IN THE MATTER of applications for Pound Road
Industrial Area [FTAA-2504-
1057]

WILLIAM HEMMING FIELD FOR COMMENTS BY CHRISTCHURCH CITY COUNCIL

Dated: 30 October 2025

Figure 3 – Indicative cross-section illustrating the recommended rural boundary provisions along Barbers Road (and Haskett's Road) frontages of the application site.

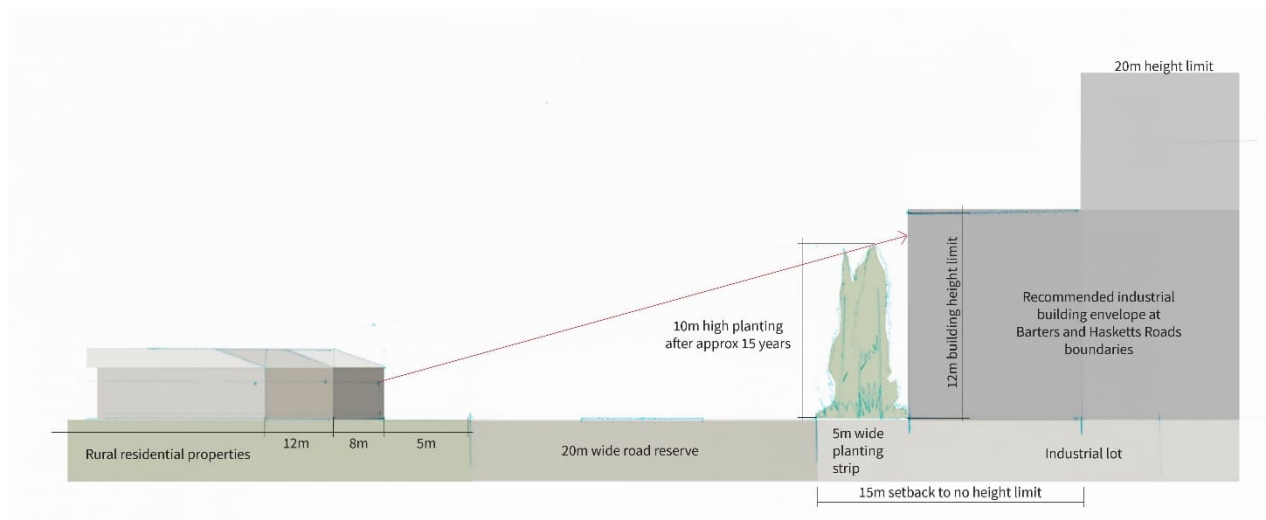
23. In my opinion, this level of tree planting and landscape setback space is not sufficient to mitigate the potential adverse landscape visual effects of the proposal on the high landscape values of the Templeton Golf Course. Potentially large-scale industrial buildings and activities could still be visually apparent through and above the proposed trees along this boundary.

51. I also note that unlimited or 20m high buildings located 5m from the Barbers Road boundary could potentially have shading effects on the neighbouring residential properties across the road, particularly in morning periods. As far as I am aware, this has not been assessed in the application.

1. *The maximum building height within the application site shall be 20m.*
2. *Along Barters Road and Haskett's Road maximum building heights shall be 12m within a setback distance of 15m from the road boundary.*

Figure 4 - Cross-section illustrating the IG industrial/residential boundary rules.

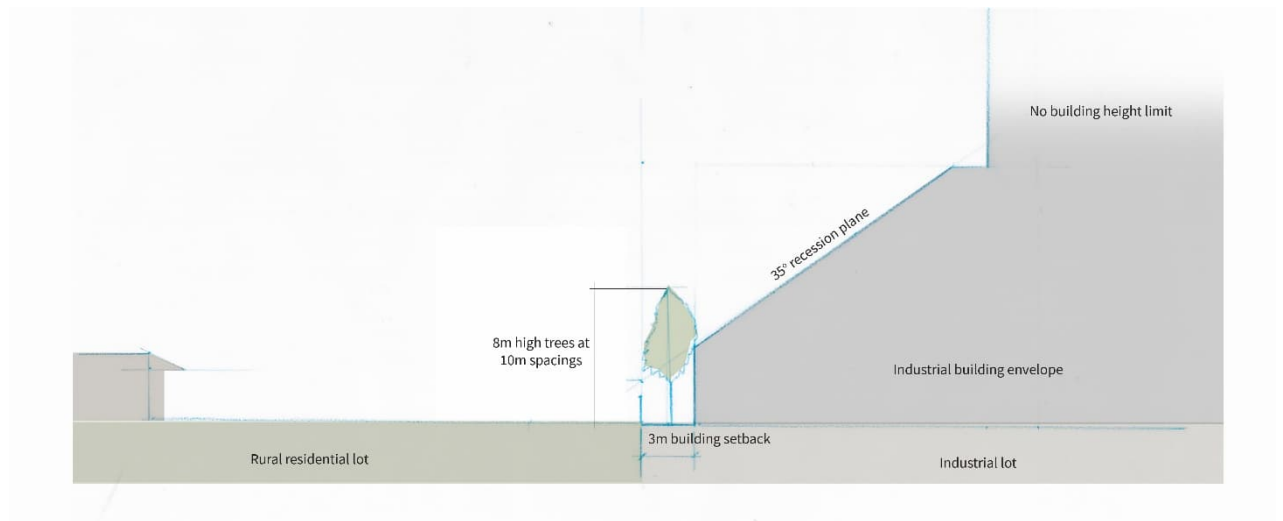
64. The internal boundaries within the application site adjoin several different property owners. I am not aware of any consultation or agreements the applicant may have made with these owners and have made the following comments on the basis that no agreements have been made. In my opinion, with the risk of 20m high industrial buildings (or greater) being located along an existing RUF zoned property boundary, further mitigation is required along these boundaries.
65. As I understand, the IG Zone rules for residential boundaries include:
- The maximum height of any building within 20 metres of a residential zone shall be 15 metres.
 - All buildings within sites which share a boundary with a residential zone shall have at least a 3 metres setback.

- A recession plane measured at any point 2.3m above the internal boundary in accordance with the relevant diagram in Appendix 16.8.11.
- On sites adjoining a residential zone, trees shall be planted adjacent to the shared boundary at a ratio of at least 1 tree for every 10m of the boundary or part thereof.
- These rules are illustrated in **Figure 4** below.

66. As I understand, these industrial/residential boundary provisions would not apply on this site where neighbouring dwellings are located. If they did apply, I would consider that they are not likely to adequately mitigate the potential visual and landscape effects on rural outlooks to industrial buildings from existing properties with dwellings.
67. To address this, I recommend that:
- Building heights should be limited to a maximum of 20m (as discussed previously).
 - Landscape strip (building setback) should be increased to 5m.
 - Evergreen trees, such as a row of exotic *Cupressus x leylandii* 'Ferndown' at 1.2m linear spacing, should be planted along the boundaries until such time (if at all), that industrial use of these rural residential sites is proposed.
68. I acknowledge that the scale of any future buildings adjacent to rural

8. *Along the internal site boundaries with neighbouring rural property boundaries, building setbacks shall be 5m and planted with a row Cupressus x leylandii 'Ferndown' in a linear spacing of 1.2m, until such time that these properties are used for industrial activities.*
